The latest planning applications at Cairngorm (2) – mountain bike trails and infrastructure

This post considers Cairngorm Mountain Scotland Ltd (CMSL)'s second planning application at Cairn Gorm, to create new mountain bike trails in lower Coire Cas. The application ([see here for planning papers](#)), as I will explain, is as poorly documented and thought through as the first, which was to create two new roads on the mountain ([see here](#)).

Drawing Title: CAIRNGORM BIKE TRAILS OVERALL TRAIL PLAN

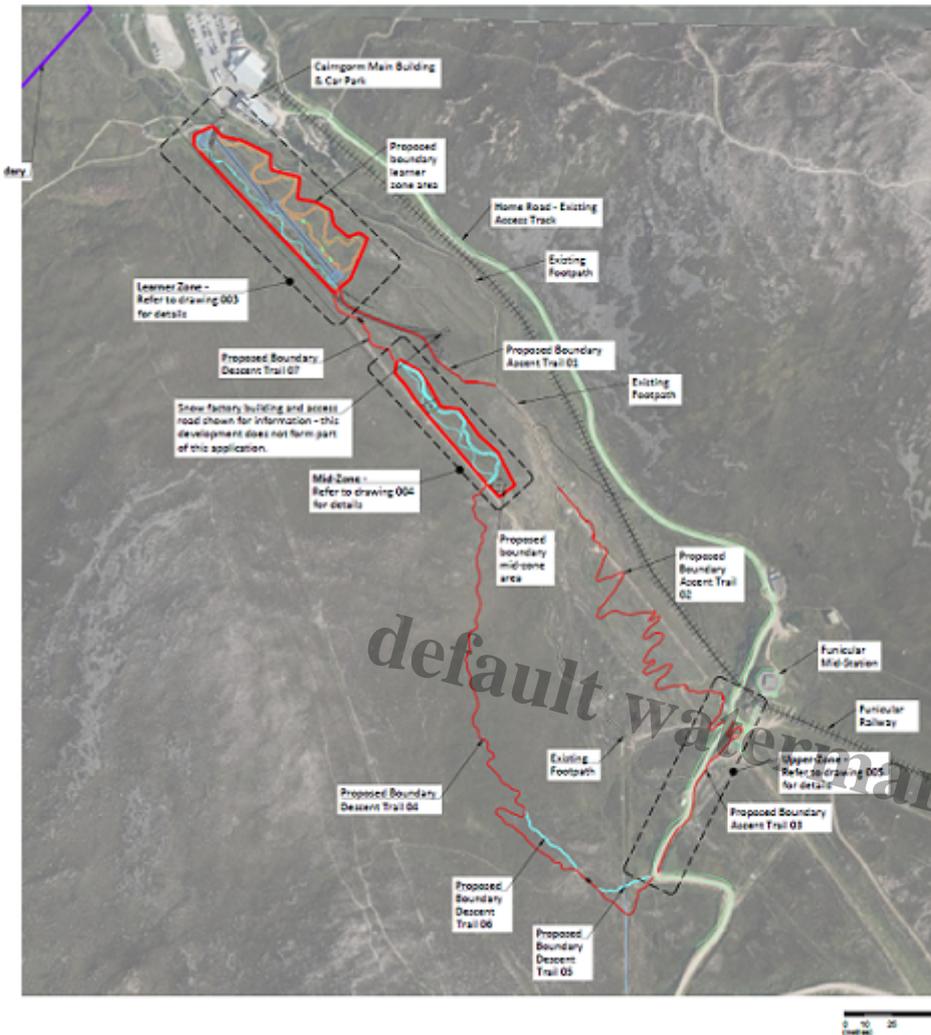
CMSL/Ryden appear to have lifted plans for the tracks, as provided by CRC Trails, and included them in the planning application but have omitted to provide any explanation to go alongside this. This makes it very hard to understand the proposals, for example:

- there is no clear explanation of how the tracks will fit with existing snowsports infrastructure and the implications for this (indeed the primary purpose of the conveyor belt in the "learning zone" would appear to be for snowsports but there is no reference to that in the application);
- there is no explanation of the purpose or concept behind the "Ascent Trail" and why it has been split in Ascent Trail 1, 2 and 3 when it all appears part of the same route;
- there is no key to the colour coding used for the "Descent Trails" although it appears (but see below) to go brown, red, blue in ascending order of difficulty;
- if this interpretation is correct, someone wanting to cycle the "medium difficulty" red trail to the shieling and then back down could then get stranded as the two trails down the mid-zone are both blue and one is labelled as "Advanced Descent 07";

How the inclusion of an 'Advanced Descent Trail' fits with the overall concept which is for a beginners' mountain bike park, is not explained;

There are also a number of important omissions from the plans:

- there is no indication of how people will access the mountain bike trails from the car park let alone how that will fit with walkers using other footpaths;
- there are no links shown to the funicular or statement about if and how CMSL intend to use it to transport bikes to the mid-station;

- while three “typical section layouts” are provided, there is no clear explanation of what layout will be used where or how these typical layouts relate to the nature of the ground.

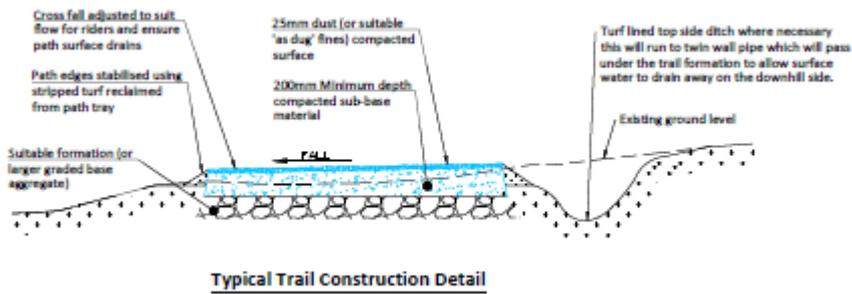
Just why a new mountain track is needed here, when vehicles on the mountain are supposed to be kept to the minimum, or what it will add to the biking experience is not explained. The section diagrams for the track donâ??t even explain its width:

At the very least it appears the footprint of the road, if this development was allowed to go ahead, would be widened by a further 2m, making it even more visible. Not what the National Park should be about.

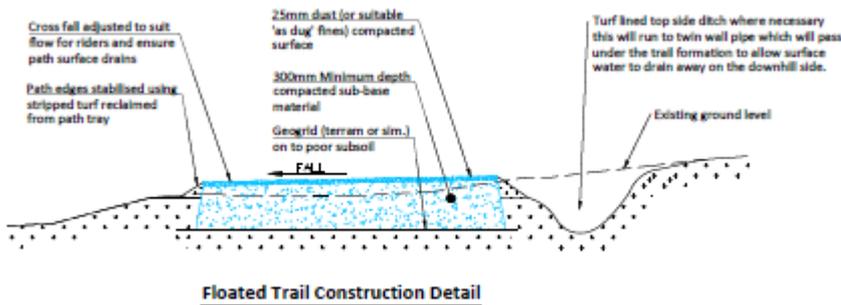
A second example. CMSL is proposing that Ascent Trail two (top map) will take a zig zag line up the ground between the Shieling Track and the snow fences and piste to the right. As you can see from the photo, the lower part of the proposed route is extremely boggy. That helps explain why one of the section drawings is for a "floating track":

CMSL has made no attempt to assess what impact a floating track with drainage ditches will have on the peatland or what impact the zig zags will have on the landscape.

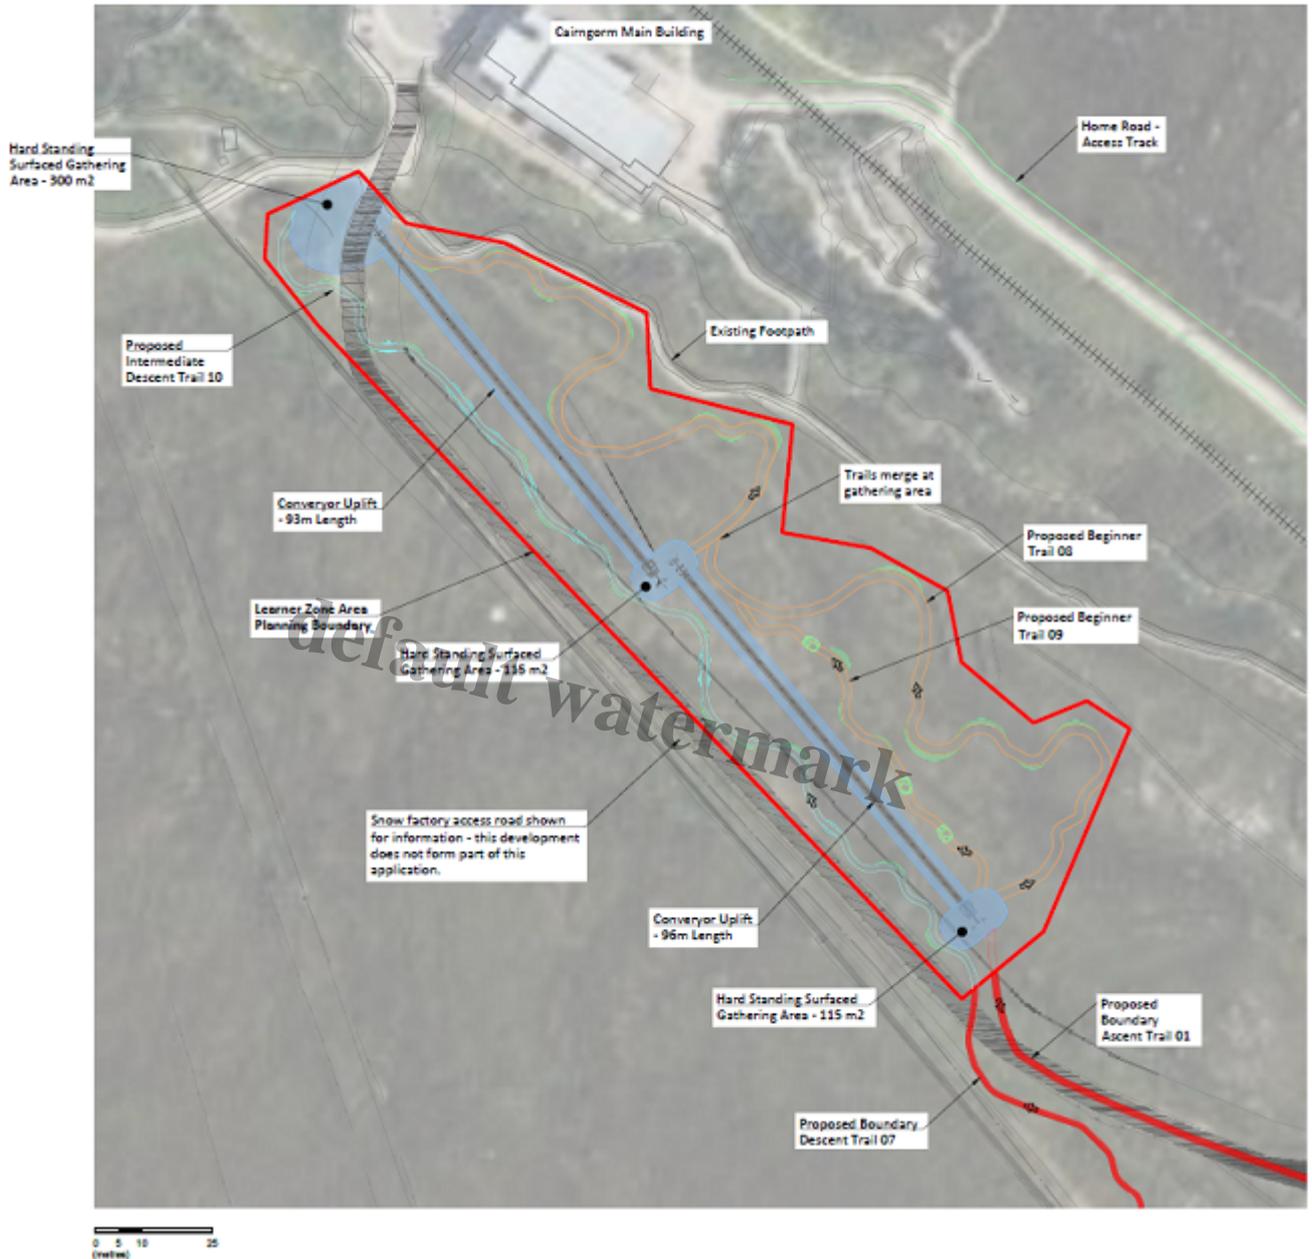
The impact of the learner zone in the area by the Day Lodge will be even greater:

In this plan the blue marks an intermediate trail whereas in the mid-section above blue means advanced. There is no key to the black shaded line which one might guess was a road but you will note that near the bottom of the map there are two parallel lines that run alongside it which are marked snow factory road.

There will be two conveyor belts which as I have pointed out before should not be needed for bikes with areas of hard standing at the top and bottom of each. Alongside the conveyor belt will be a new access road to the re-located snow factory, which CMSL says is not part of this application. It should be! The further development of this bit of ground by the Day Lodge should be considered as a whole, not piecemeal.
